**From:** Peter J. Hinck <[REDACTED]>  
**Sent:** Thursday, July 19, 2012 11:40 AM  
**To:** 'Fred Marinelli'  
**Cc:** Cory D. Anderson; Tina Pint; Al Trippel; Carlson, Erik (DNR); David Blaha; Houston Kempton; Paul Haby; John L. Adams; Jim Scott ([REDACTED])  
**Subject:** RE: Cat 1 stockpile pH

Site: Mine Site

Activity: GoldSim Task 2 QA

Issue: Cat 1 stockpile

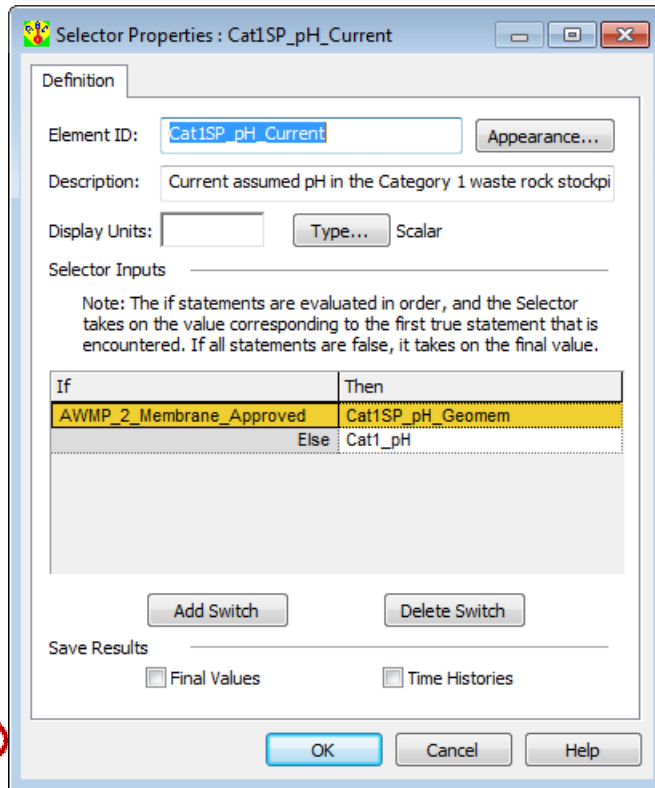
pH during closure with geomembrane installed

Model appears to be using a P50 pH = 7.25, which is appropriate for a soil cover.

Input tables indicate that the model should use P50 pH = 7.95 for a geomembrane cover.

We believe the programming issue is in Element ID: Cat1SP\_pH\_Current.

Cat 1 pH affects numerous geochemical calculations involving the concentration of constituents in Cat 1 seepage.

You are correct that the model files submitted 2 weeks ago did not have the pH of the Category 1 Waste Rock Stockpile modeled correctly. This was the result of some testing that I was doing, and I neglected to change the value back before submitting the models. See the screen shot below for the correct (and current) modeling of the referenced element (Cat1SP\_pH\_Current), with the line that needs to change circled (I believe the version you have just lists this as "false").

Erik et al., this error was corrected prior to performing the modeling runs used in the AWMP Version 2, submitted last week. The full package of model results posted to the project website, however, were from a modeling run that included this error. The effect of this change on the ultimate concentrations in the Partridge River and groundwater is minimal, but it does represent an inconsistency in the model. Please advise if you'd like us to update the posted results spreadsheets.
